March 24, 2026

MEMORANDUM

SUBJECT: EPA Alternative PISC Review and Approval Memorandum for the Front Range Storage Complex Class VI permit– Permit Number CO62455-12770; Weld County, Colorado

Figure 1. Sensitivity analysis for Front Range 1-1 AoR delineation.

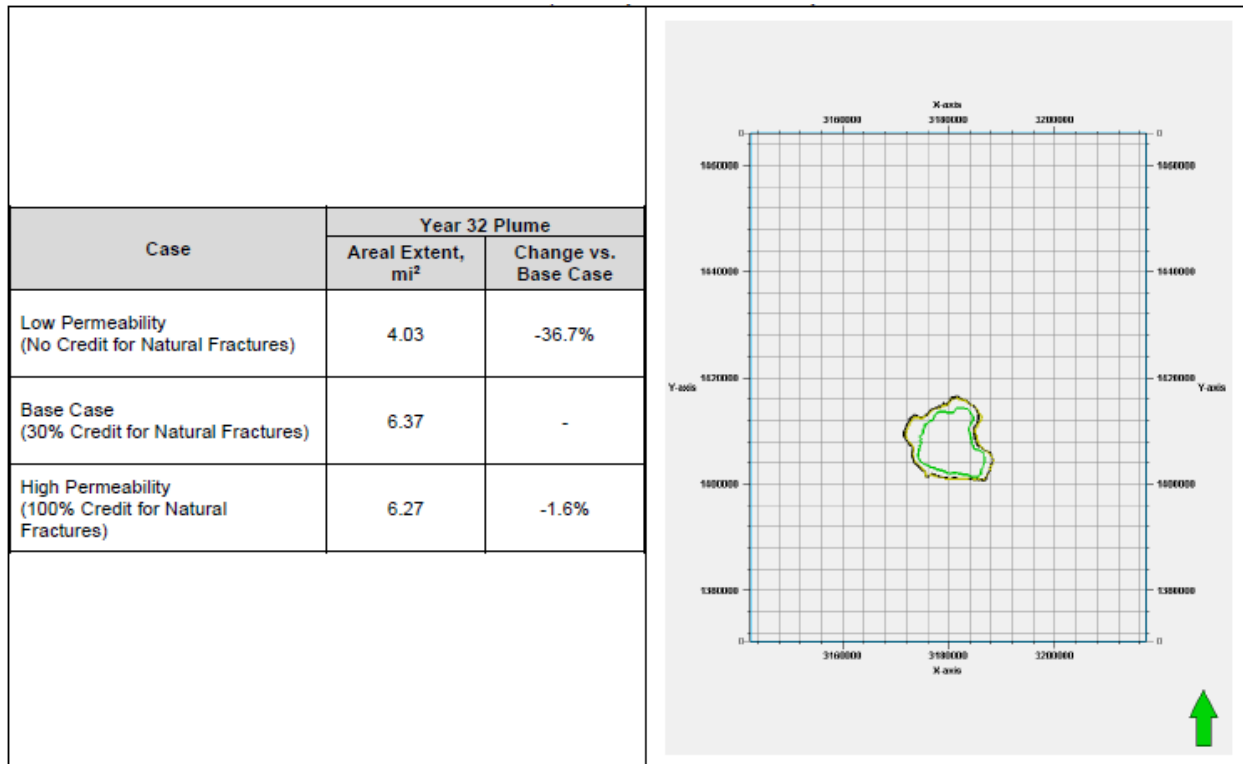
In conformance with 40 CFR 146.93(c)(2)(vi), CSS conducted a sensitivity study on the impact of permeability on the areal extent of the Year 32 plume, representing 12 years of injection and 20 years post-injection, to support the requested 20-year alternate PISC timeframe. Permeability was selected as the independent variable since it is believed to have significant uncertainty due to the unpredictable impact of natural fractures within the injection zone; all other reservoir properties were held constant at their Base Case values. Three cases were established:

The areal extent of the Year 32 plume was selected as the dependent variable since it is a proxy for the areal extent of the AoR. Figure B.3-6 summarizes results from the sensitivity analysis. All three cases show the same general shape for the areal extent of the Year 32 plume. The plume for Low Permeability Case is the smallest, while plumes for the Base Case and High Permeability Case are essentially identical. The results demonstrate that permeability is potentially a useful calibration variable for history matching activities associated with future injectivity testing and field data from the injection period; however, the results also indicate the plume size predicted by the computational model becomes insensitive to permeability when the natural fracture credit exceeds 30%.
